# **DRB July 16, 2015**

Revised Schemes per May 21 DRB Comments

### 3. Penthouse

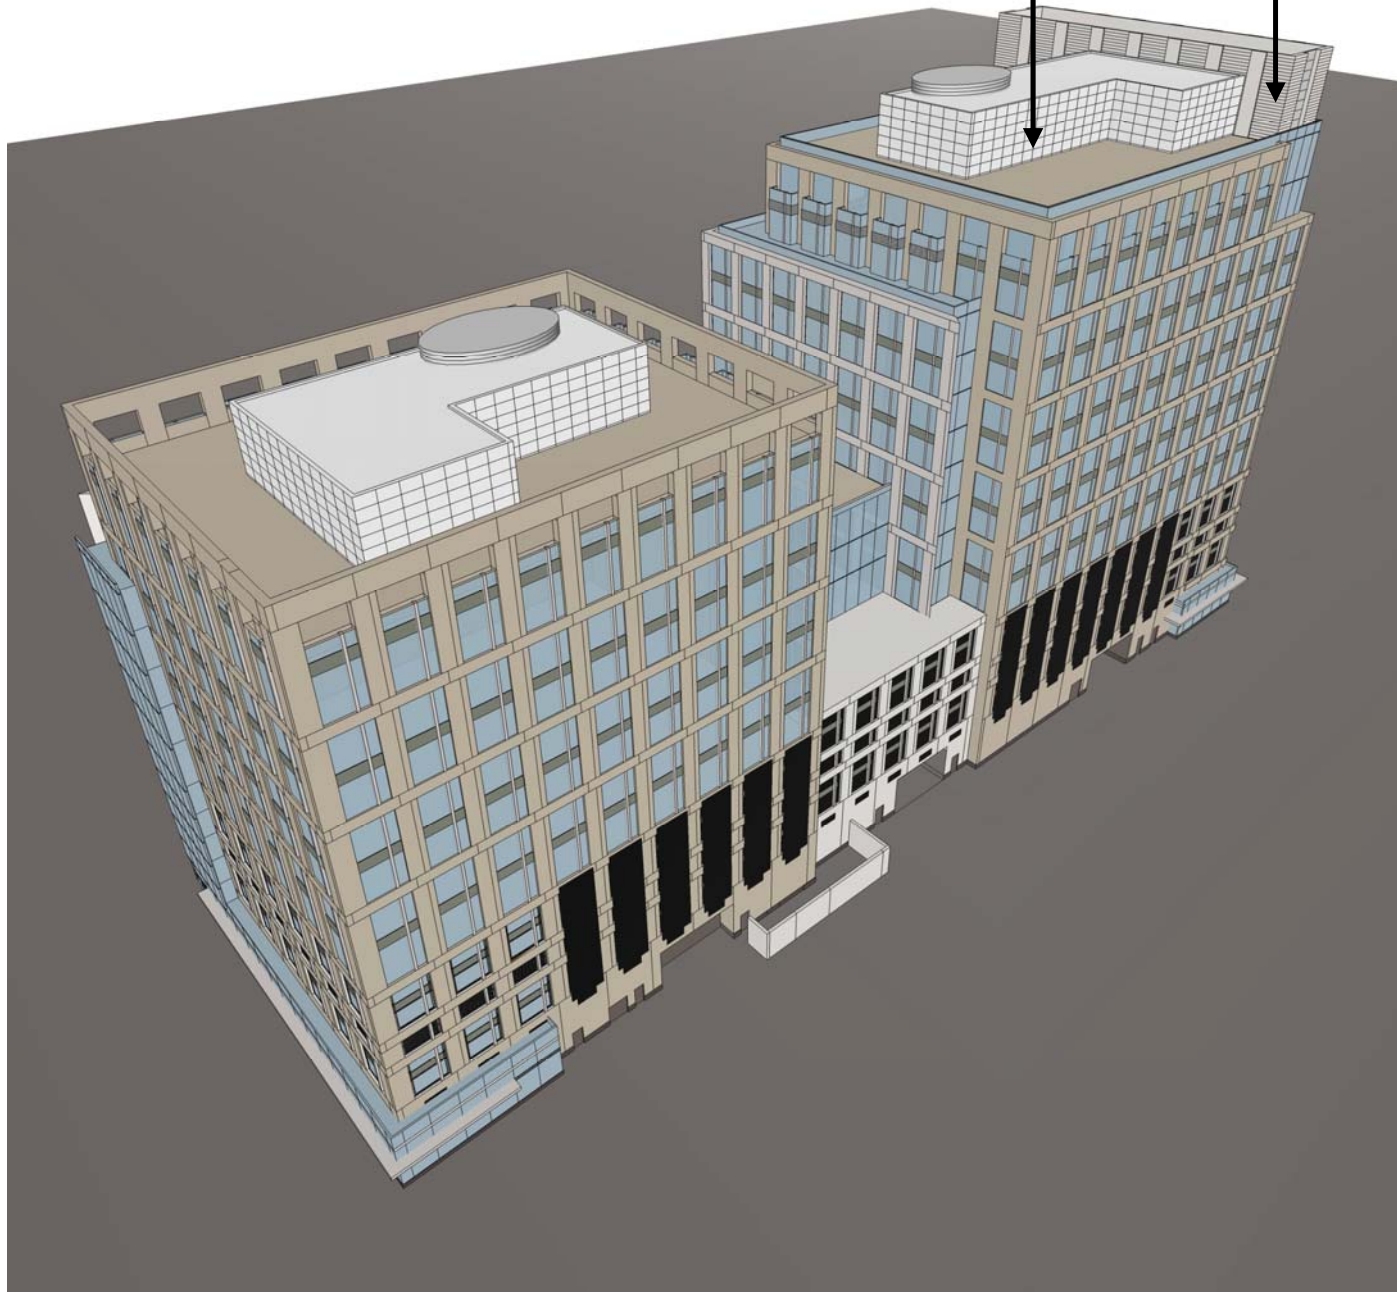
Penthouse Lower than Tower  
Denser Horizontal Reveal Pattern All 4 Sides

# 4. Southwest Corner

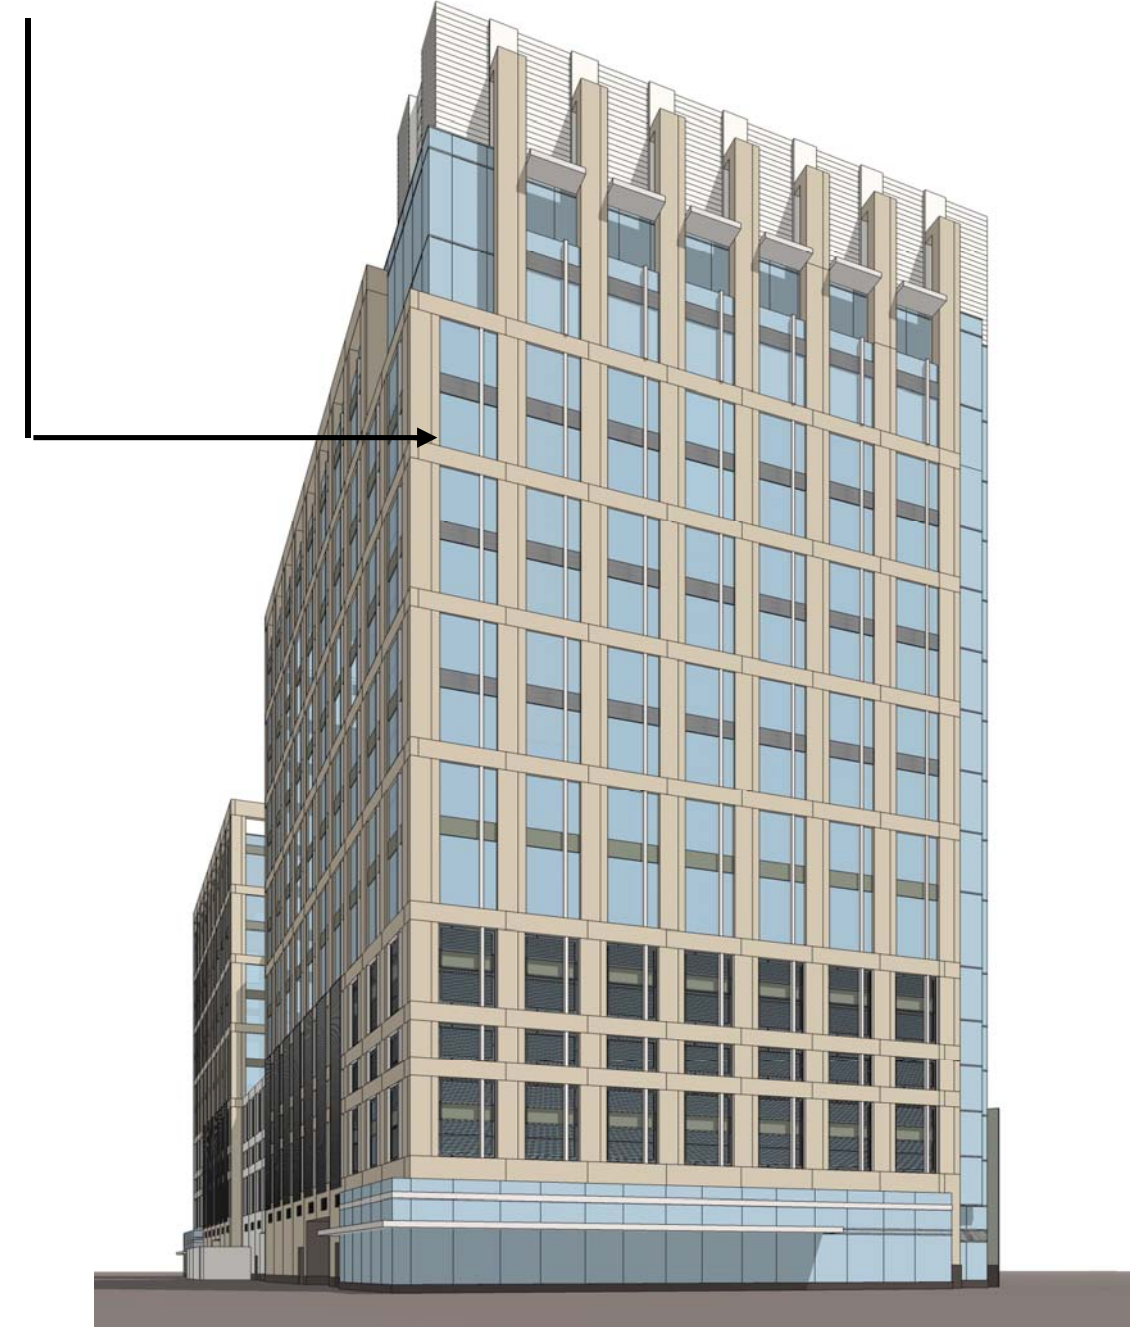
Clarified Corner Volume with Refined Tower Articulation

# 4. Southwest Corner

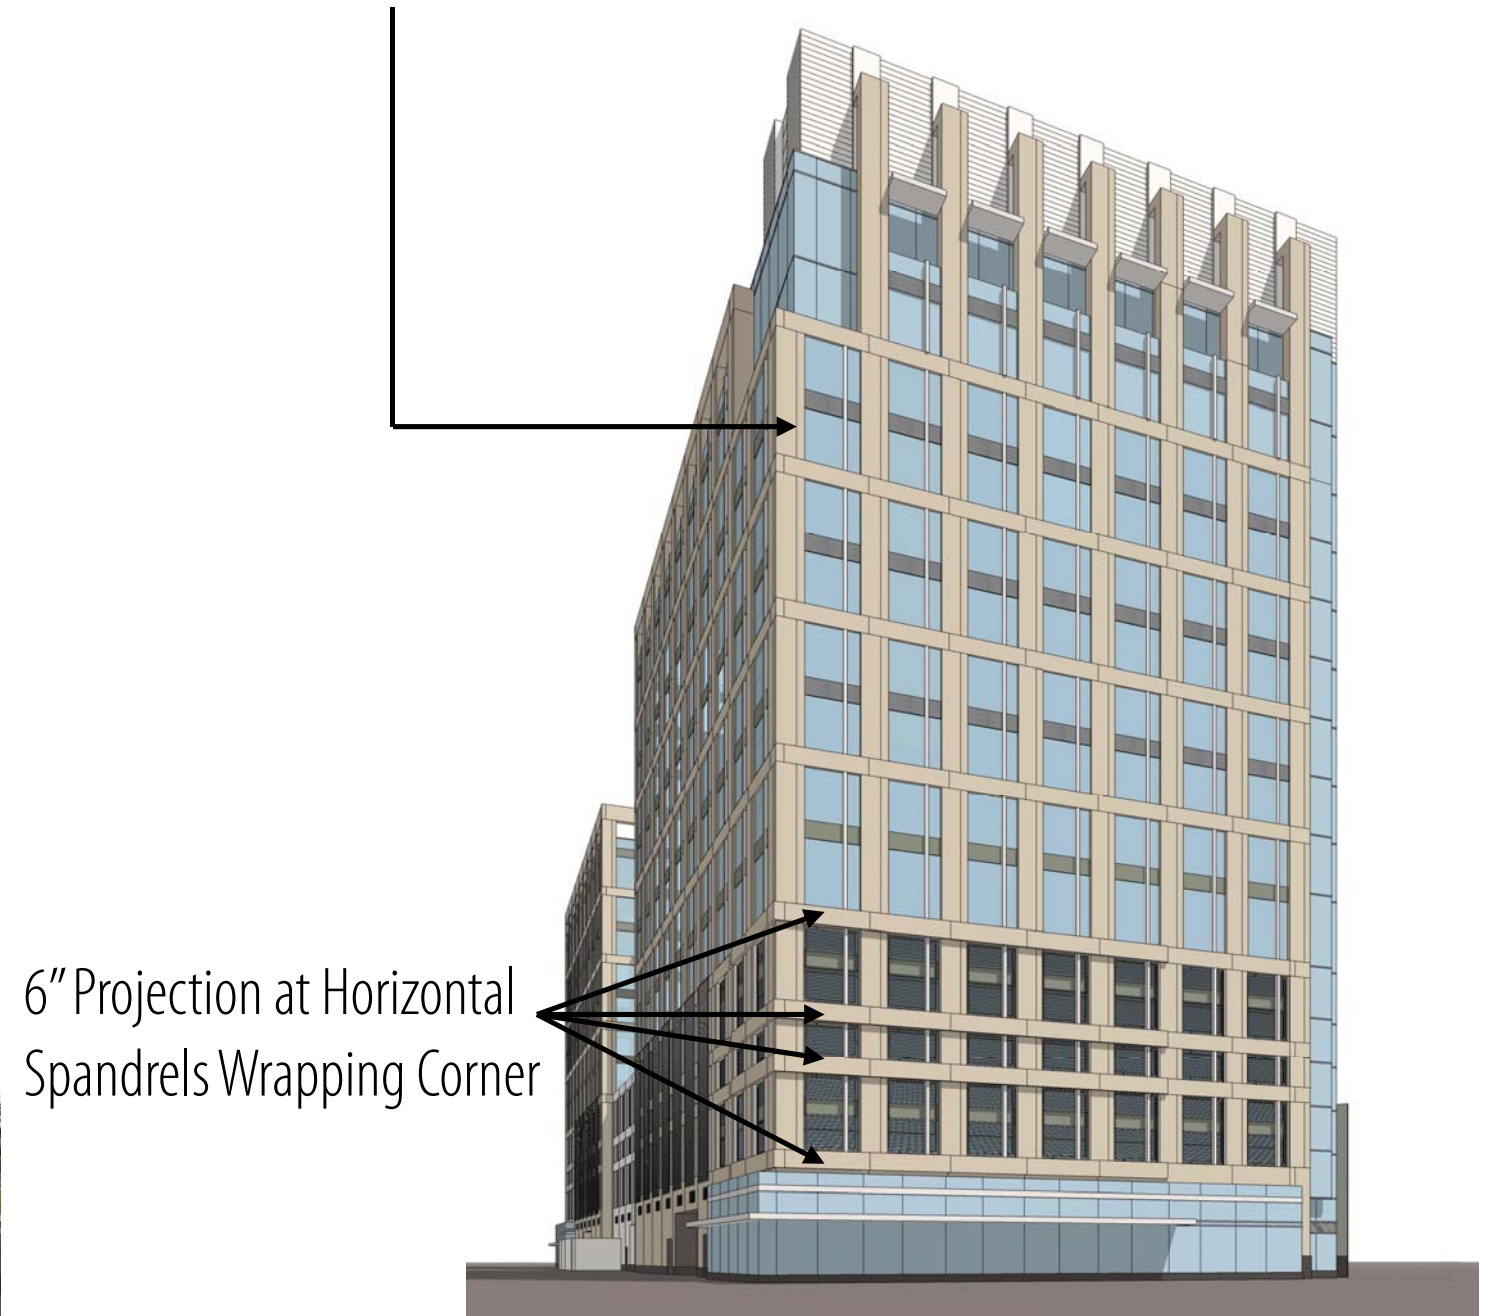
Clarified Corner Volume with Refined Tower Articulation
